# Rezoning Transportation Analysis

Petition Number: 2026-024

Date	Description
04-23-26	First Review (CM)
05-21-26	Second Review (CM)

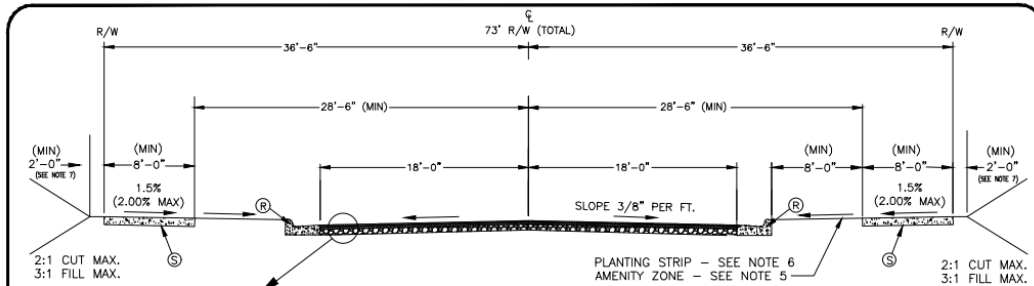
- a. ~~West Summit Avenue: Location of future back of curb and gutter needs to be a minimum 17.5 feet from centerline of roadway. Existing curb and gutter is not required to be relocated.~~

~~Label and dimension the curb and gutter from the centerline for each road on the site plan.~~

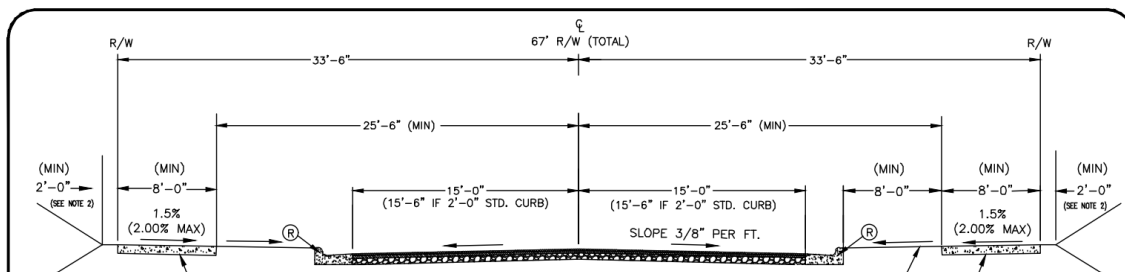
- b. **Merriman Avenue:** Location of future back of curb and gutter to be a minimum 20.5ft from centerline of roadway per CLDSM U-05. Existing curb and gutter is not required to be relocated.

Label and dimension the curb and gutter from the centerline for each road on the site plan.

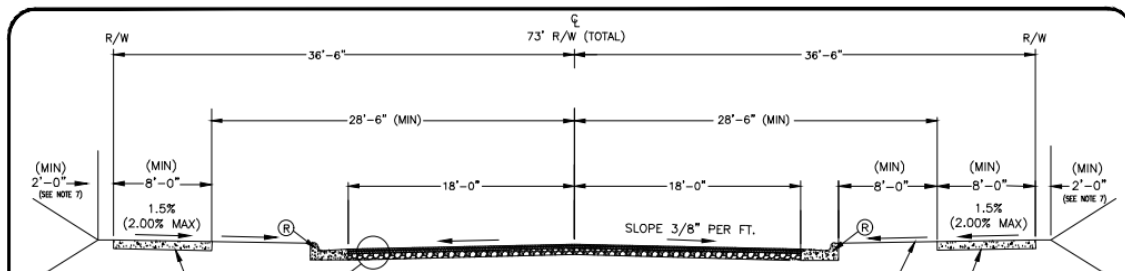
- c. **Spruce Street:** Location of future back of curb and gutter to be is a minimum 17.5 feet from centerline of roadway per CLDSM U-03. Existing curb and gutter is not required to be relocated.

Label and dimension the curb and gutter from the centerline for each road on the site plan.

**C** W SUMMIT AVE SECTION  
1/8" = 1'-0"

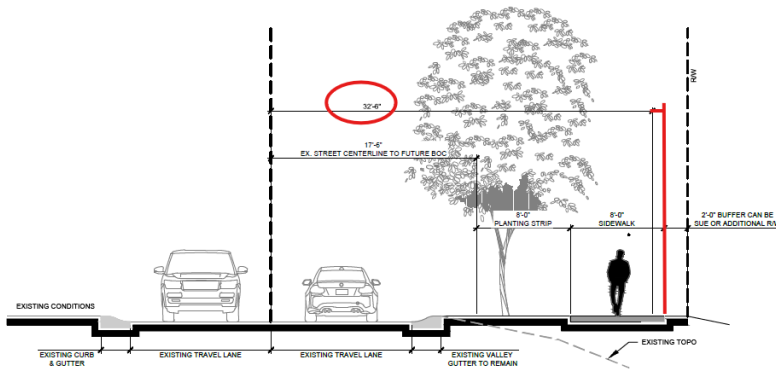
- 15. **New Comment 5/21/26:** Update leaders/dimensions in street cross-section C to show FBOC pointing to back of curb location.
